**Additions and Renovations
Platt Technical High School
Milford, CT**

ADDENDUM NO. 1

July 23, 2019

7 TYPICAL TREAD AND RISER DETAIL

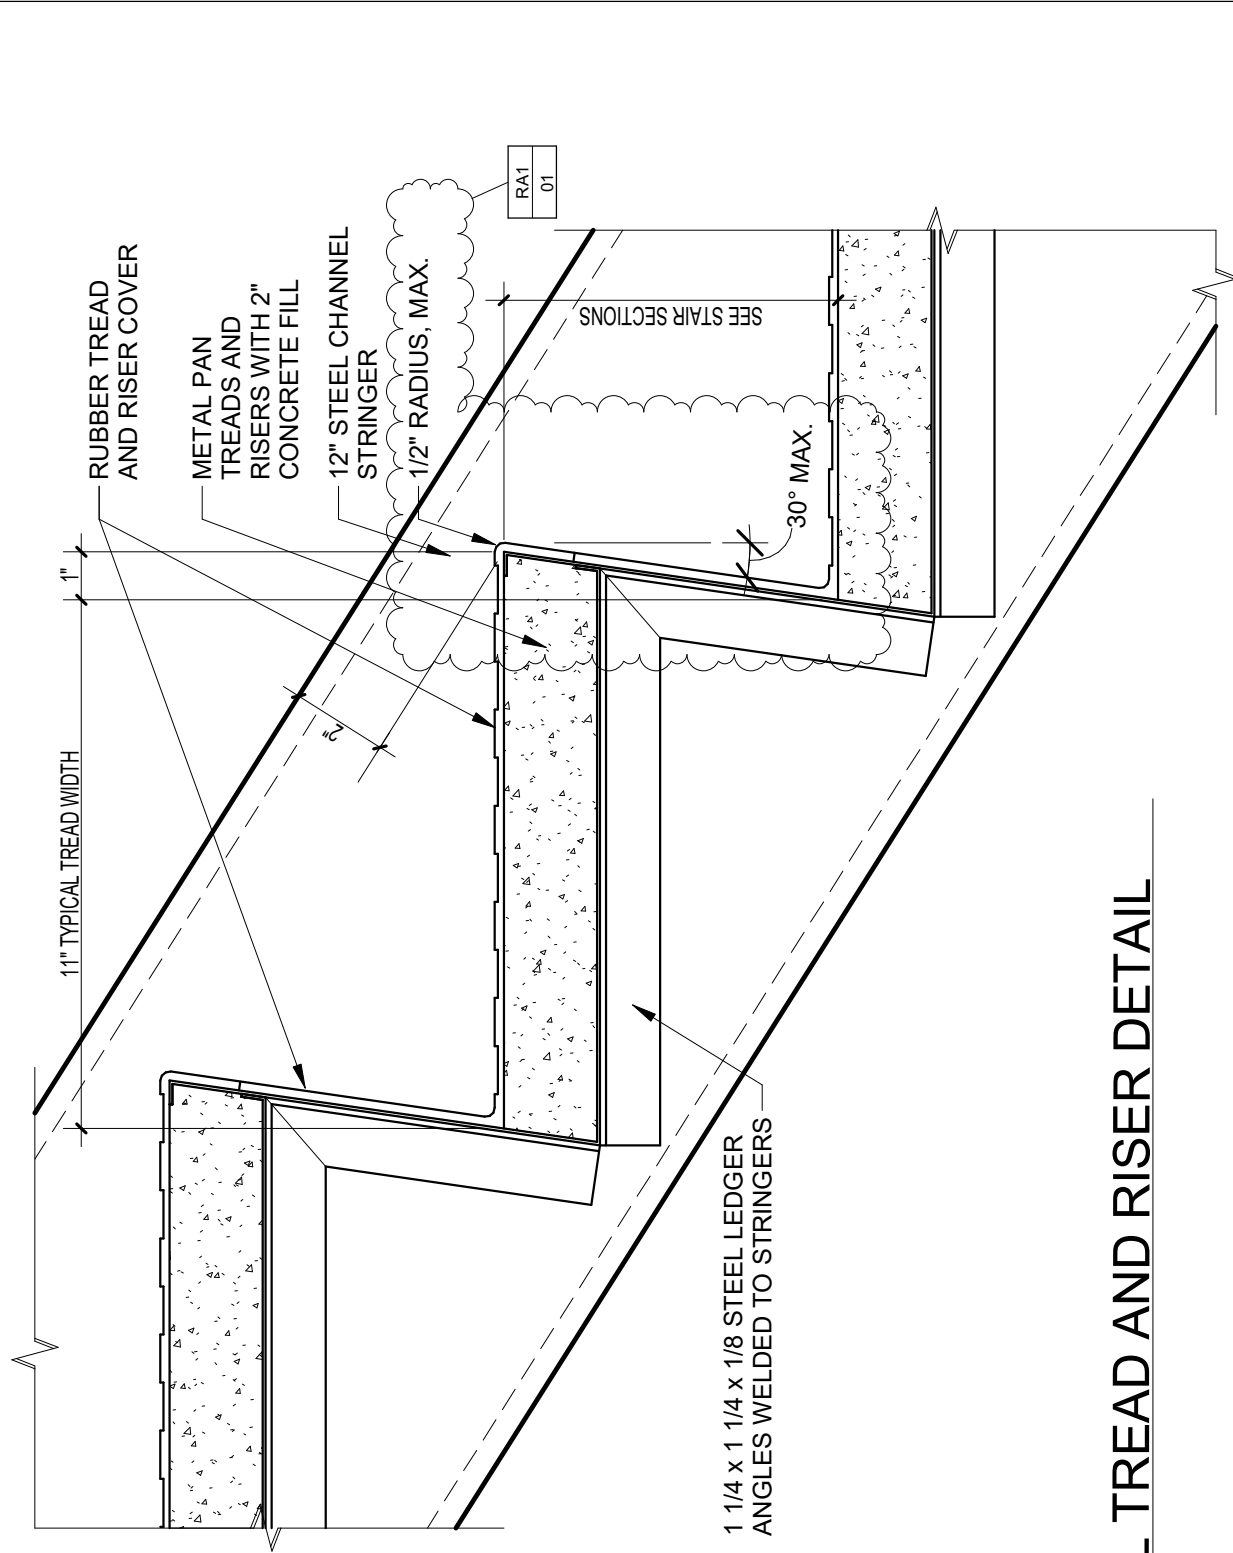
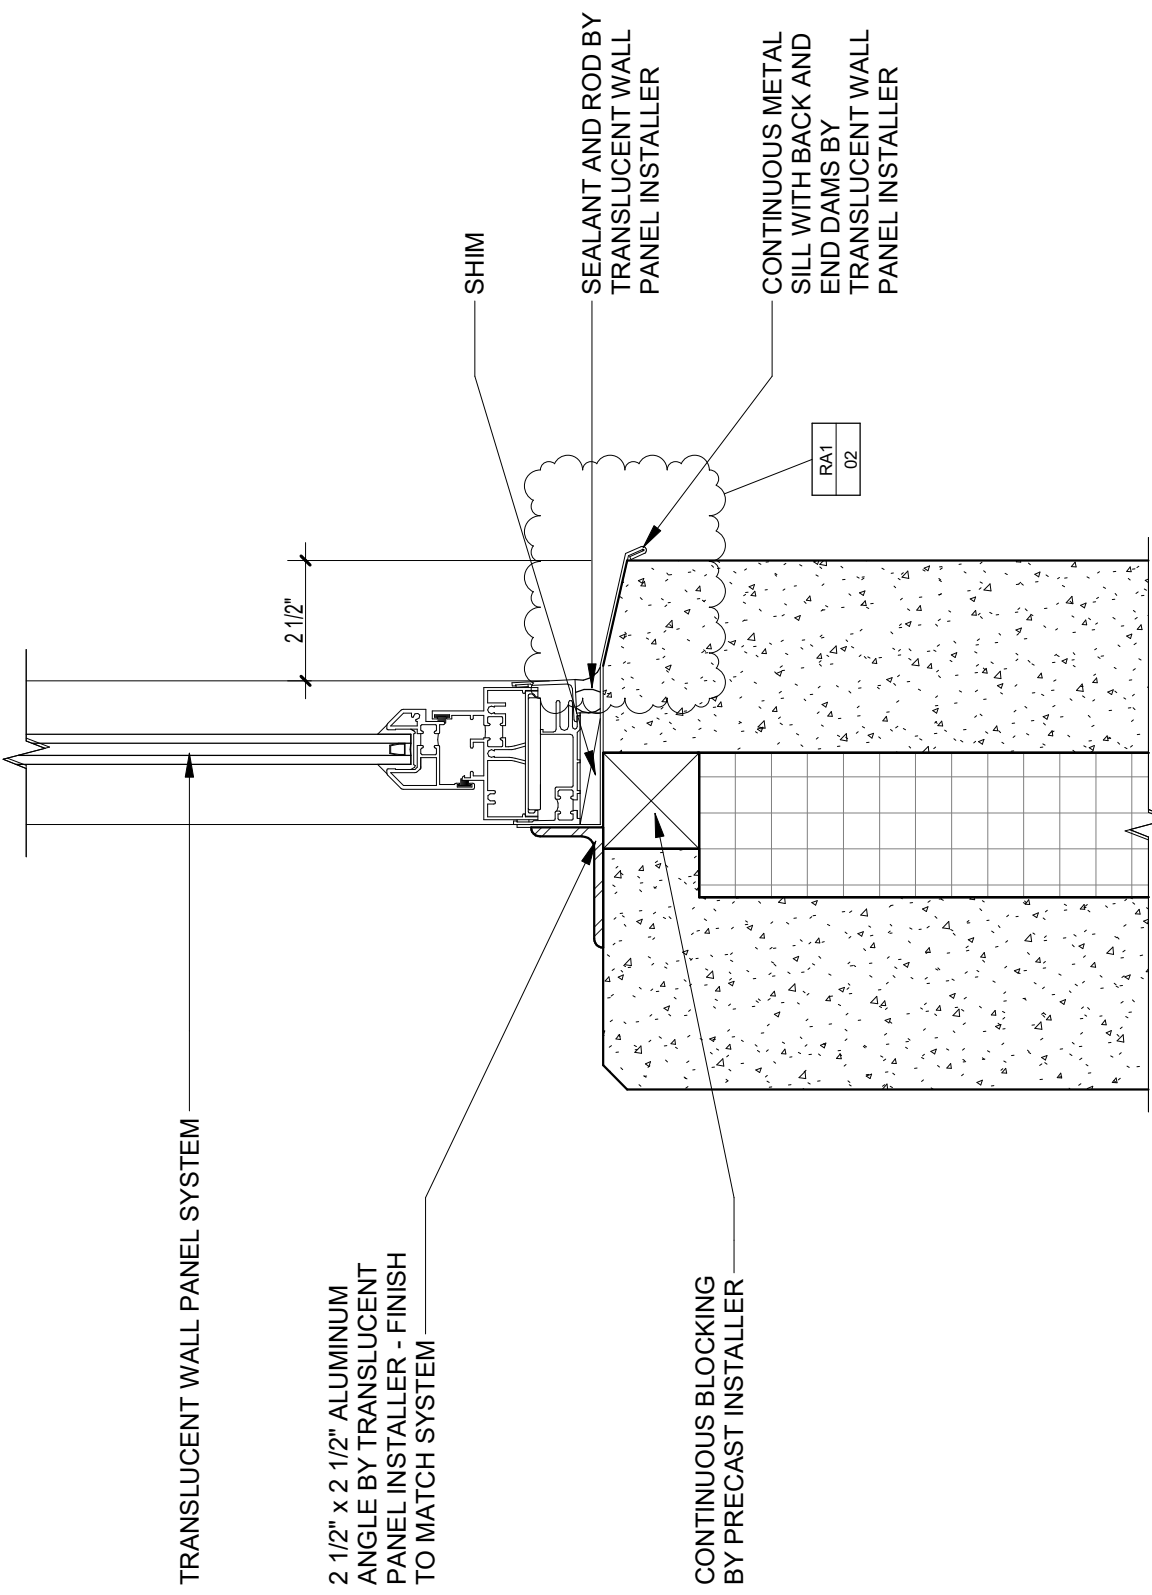
- ADD 1-016 A6-3-20 – TRANSLUCENT WALL PANEL AND LOUVER DETAILS**
Detail 1: Revise Pre-cast sill profile at Translucent Wall Panel Sill Detail. Refer to sketch RA1-02.
- ADD 1-017 A7-1-7 – STAIR DETAILS**
Detail 7. Added code requirements for nosing projection at Typical Tread and Riser Detail. Refer to sketch RA1-01.

1 FIRST FLOOR FIRE PROTECTION PLAN - AREA E
 1/8" = 1'-0"
 REFER TO FP0-1 FOR FIRE PROTECTION SYMBOLS, LEGENDS & NOTES.
 REFER TO FP3-1 FOR FIRE PROTECTION DETAILS.
 REFER TO FP2-1 FOR ZONING

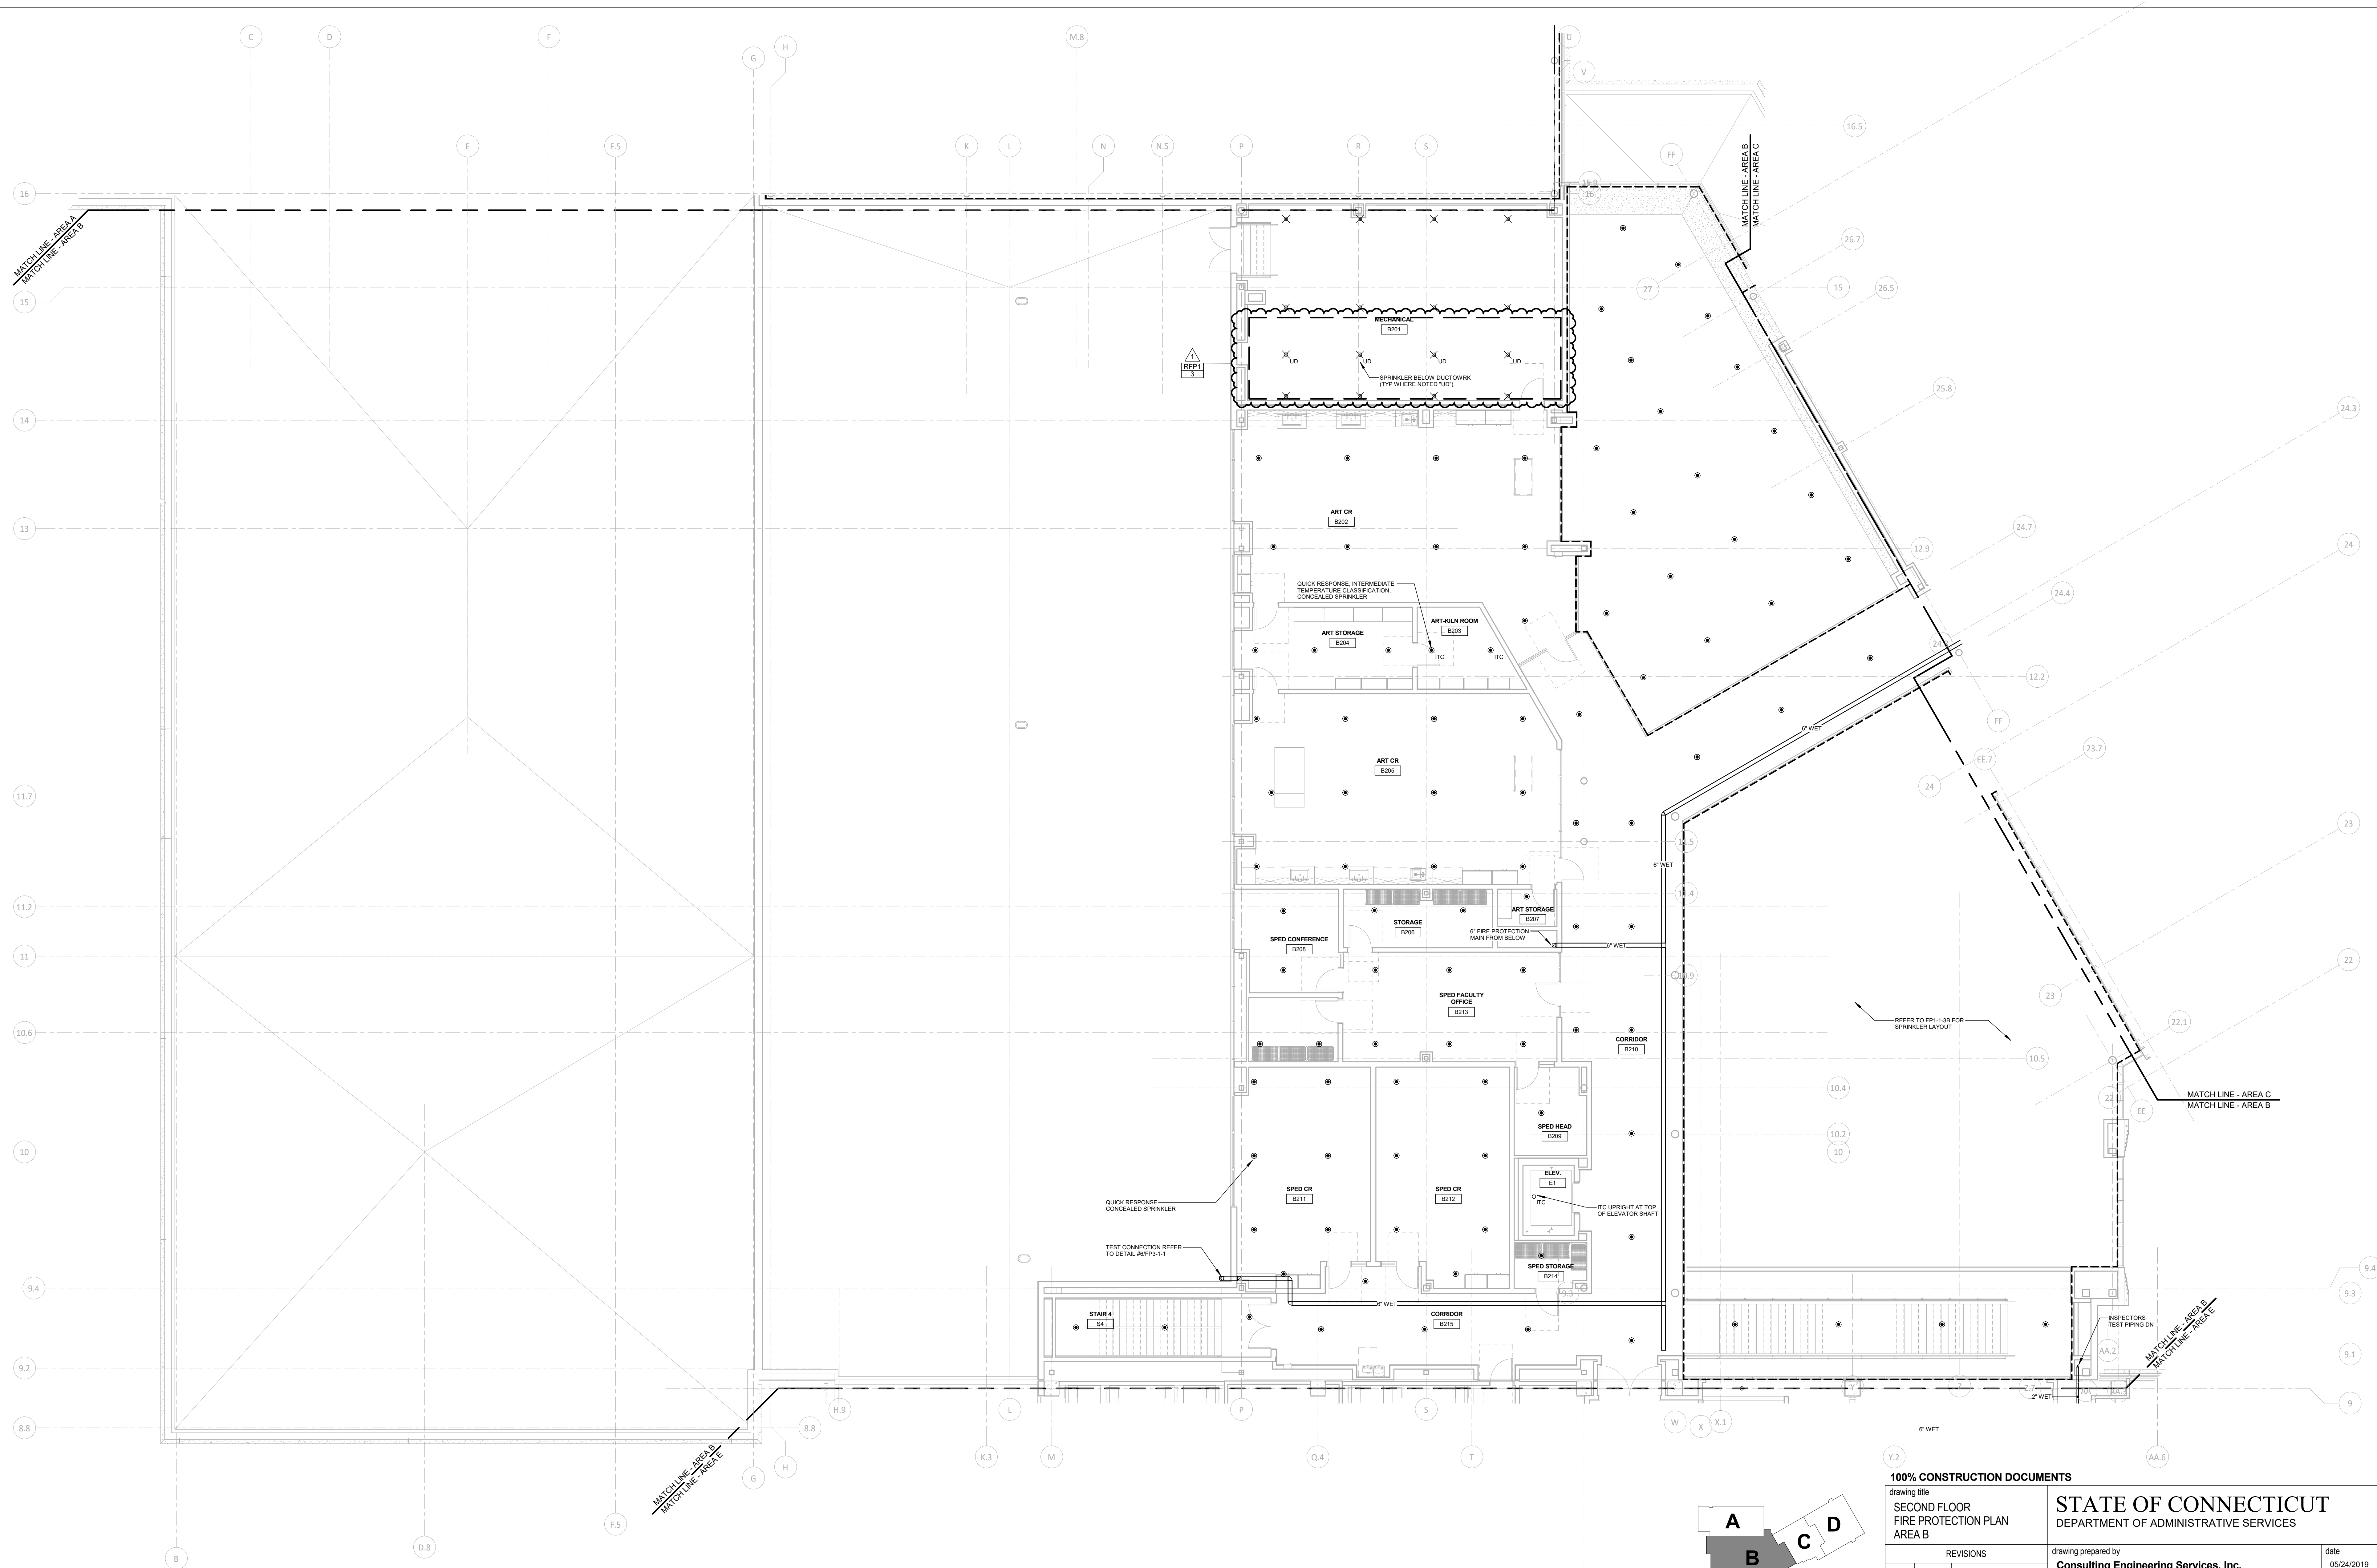
- ADD 1-019 DRAWING FP1-1-1E – FIRST FLOOR FIRE PROTECTION PLAN – AREA E**
Added second nozzle for suppression system, RFP1-1.
Revise note related to dust collection suppression system, RFP1-2.

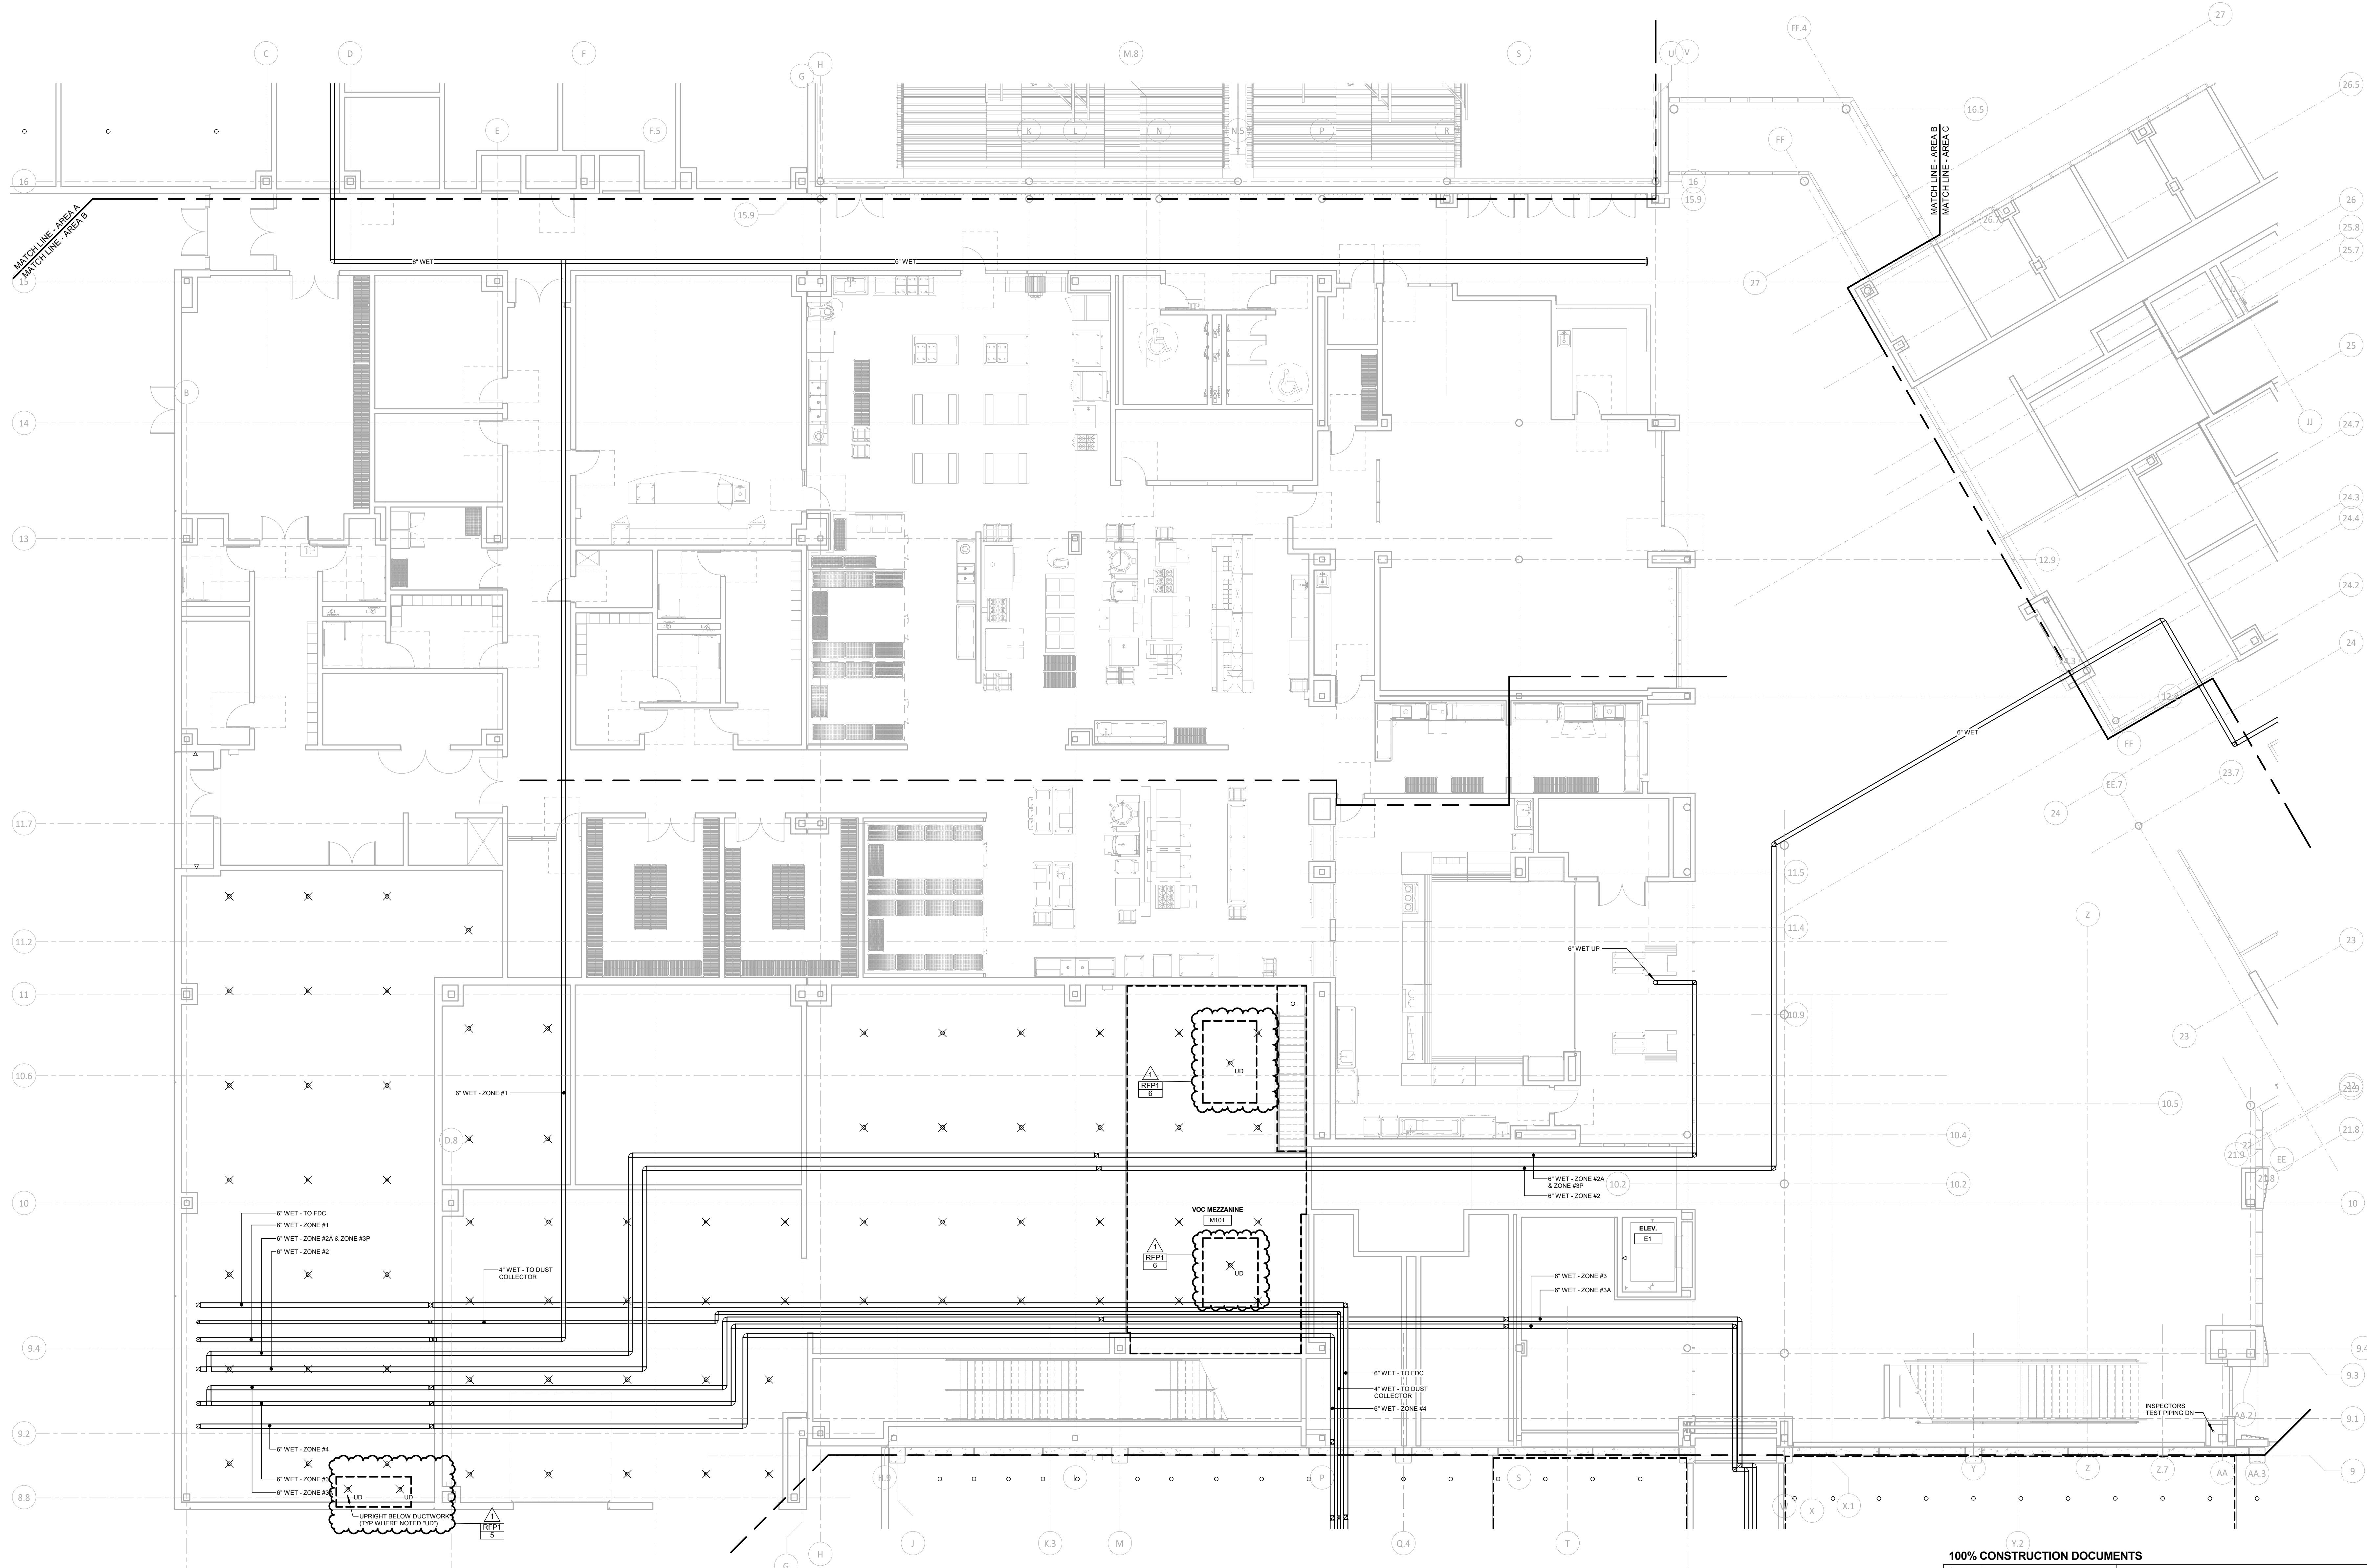
- ADD 1-020 DRAWING FP1-1-2B – SECOND FLOOR FIRE PROTECTION PLAN – AREA B**
Added sprinklers below ductwork in Mechanical Room B201, RFP1-3.
- ADD 1-021 DRAWING FP1-1-3C – CLEARSTORY FLOOR FIRE PROTECTION PLAN – AREA C**
Expanded note for sprinklers below ductwork, RFP1-4.
